AMENDMENT NO. 2
TO
PRELIMINARY
HAZARDS SUMMARY REPORT
FOR THE
DRESDEN NUCLEAR POWER STATION
By: Commonwealth Edison Company
General Electric Company

Amendment No. 2, dated August 25, 1958, includes revisions to certain portions of Amendment No. 1 of the Preliminary Hazards Summary Report reflecting refinements in reactor physics data and the analysis of certain hypothetical reactor accidents, plus additional information on "start-up and coolant loss accidents" and on one of the fuel model heat transfer functions.

AMENDMENT NO. 2

DRESDEN NUCLEAR POWER STATION

FIGURE 1
5-ROD START-UP ACCIDENT

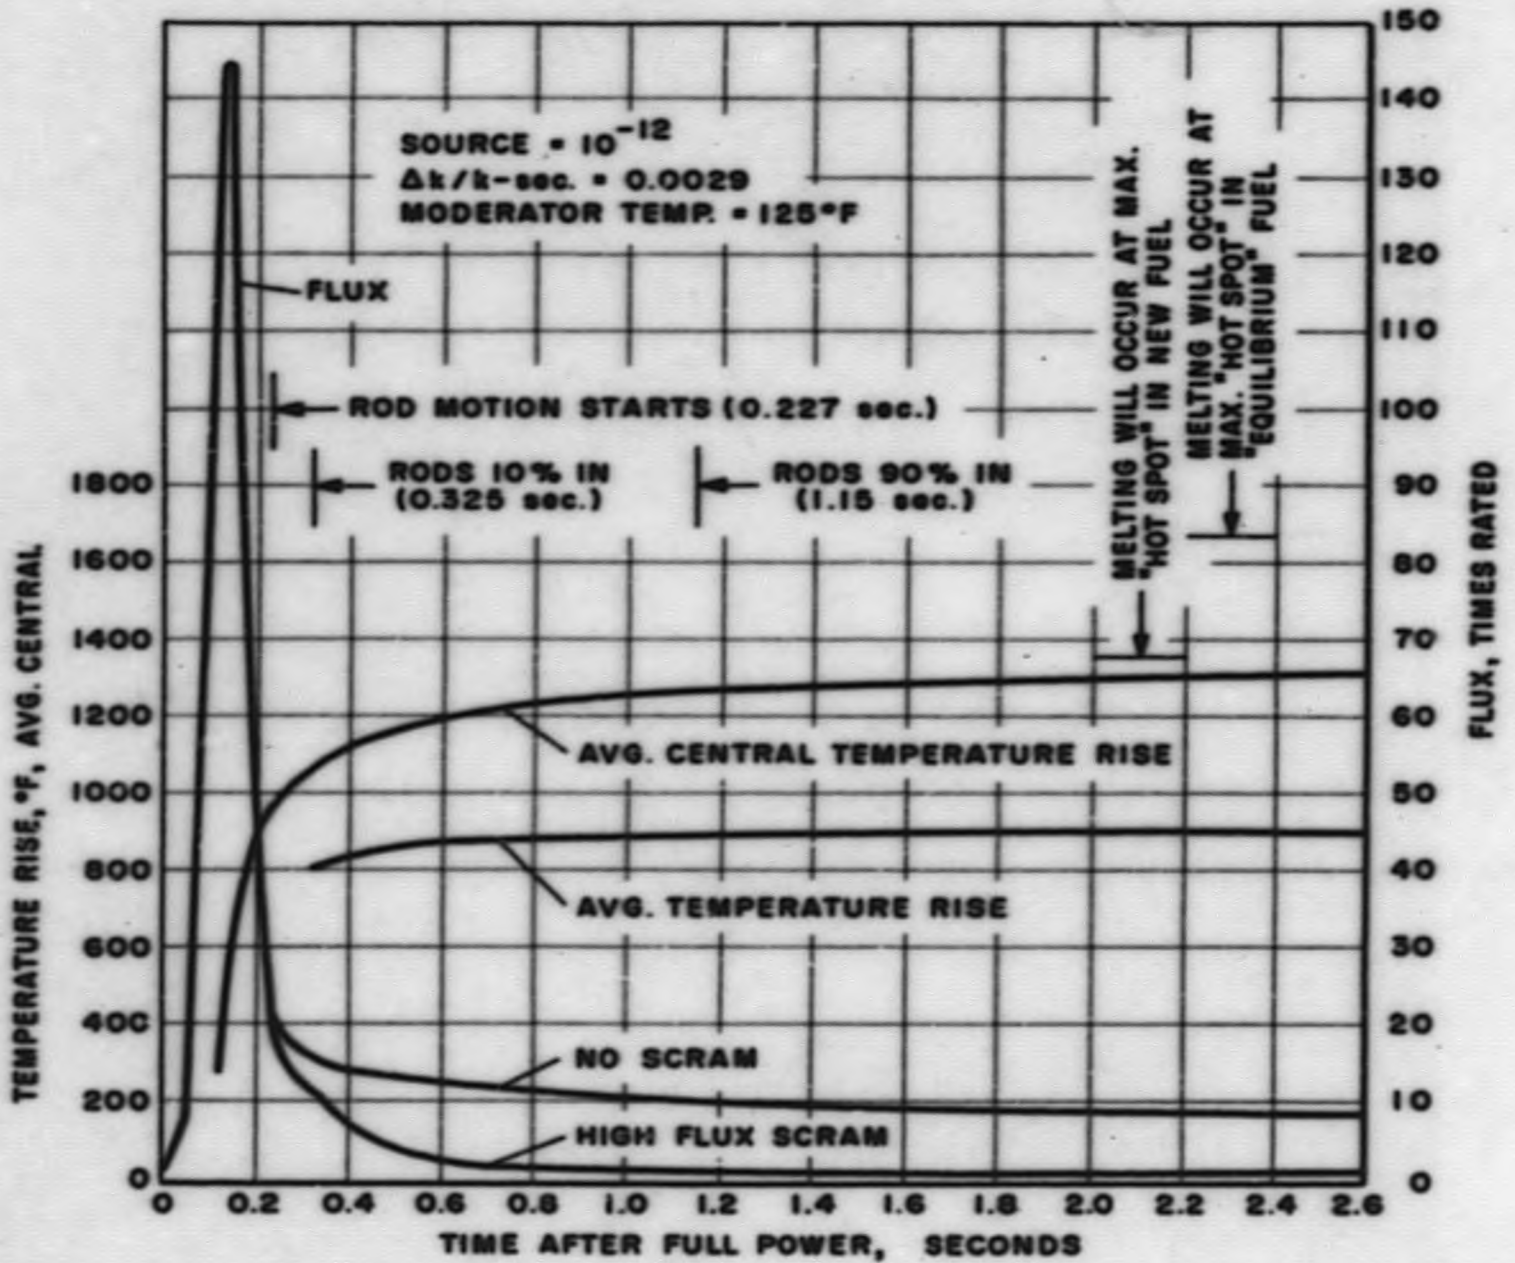
The reactivity insertion rate under the above conditions is calculated to be $0.0029 \Delta k/k$ per second. On the basis of an experimentally determined 0.22 second flux scram delay time* and a calculated negative fuel-temperature coefficient of $0.9 \times 10^{-5} \Delta k/(k)(^{\circ}F)^{**}$, this accident would result in a localized flux peaking and possibly some melting in the center of a few of the fuel elements. This would not cause the cladding of these fuel elements to fail.

The flux peaking in this area is calculated to be restricted to a small area of the core, about two feet in diameter and six feet long. The temperature rises in the fuel in this area are calculated to be about as follows:

- a. Overall average 900°F
- b. Center average 1300°F
- c. Center maximum 3800°F (for fuel of equilibrium exposure)
- d. Center maximum 4700°F (for new fuel)

A plot of the flux, temperature rises and the sequence of events in this incident are shown in Figure 1.

FIGURE 2
5-ROD START-UP ACCIDENT
WITHOUT SCRAM

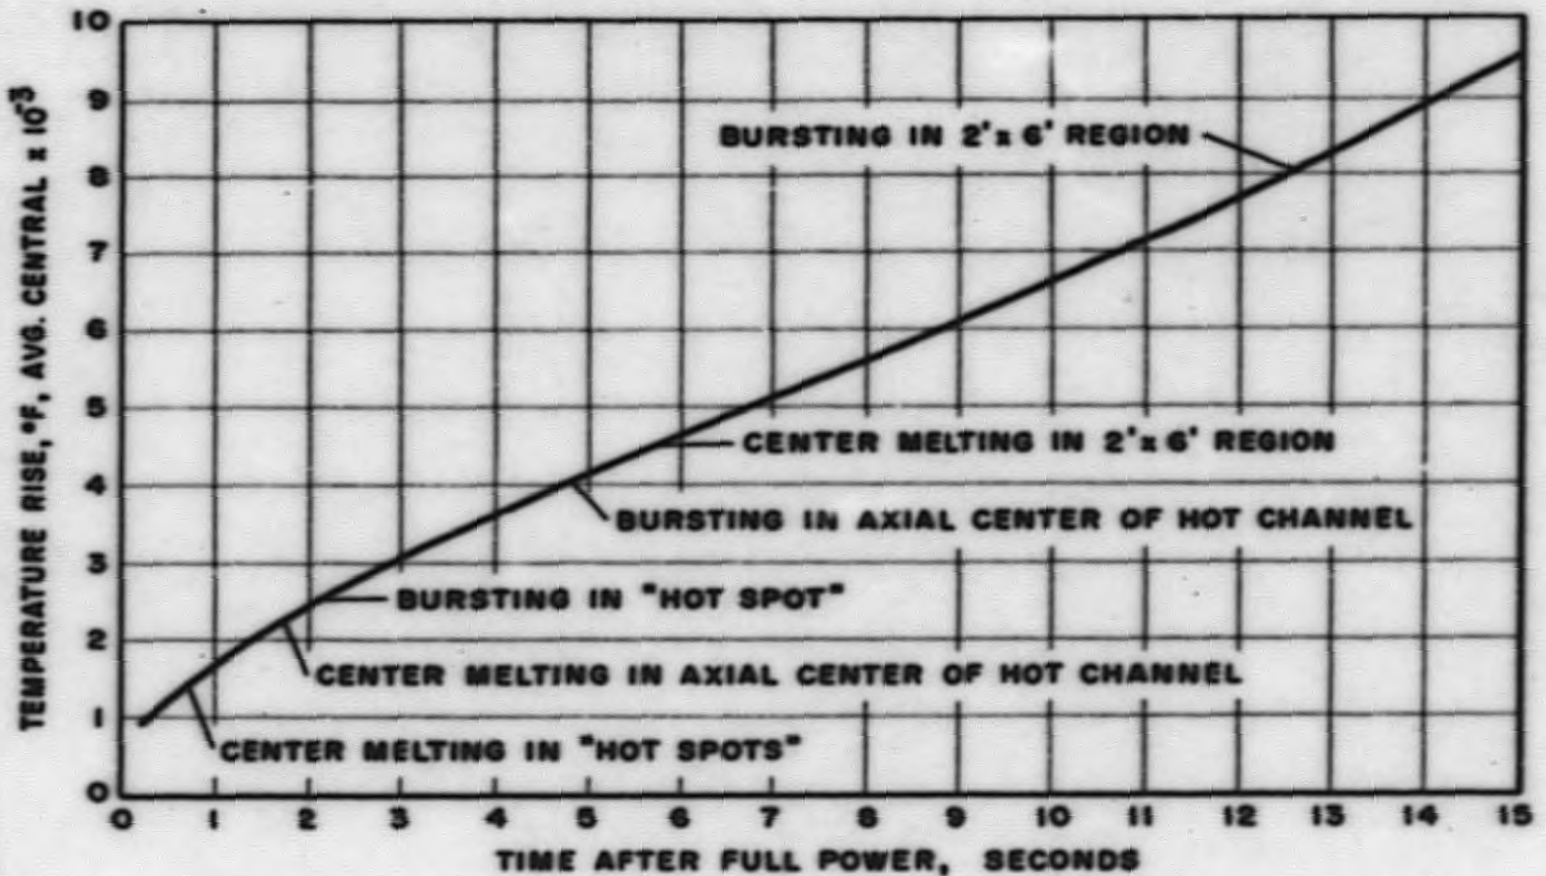
From a safeguards standpoint, it is pertinent to note that even if both the period and flux level scram circuitry were to fail coincident with the above start-up accident (an incredible sequence), and there was no manual scram, the accident would be terminated by self-destruction of a portion of the core without any adverse effects to the public. It is calculated that about two and one-half percent of the core would be melted, but no significant amount of the fission products should be released from the primary system. The pressure rise in the reactor in this case (even in the unlikely event a zirconium water reaction were also to be initiated) would be very nominal, probably less than 60 psi. Figure 2 shows a plot of average fuel center temperature rises in such an incident. The times at which significant changes in state may occur are also shown.
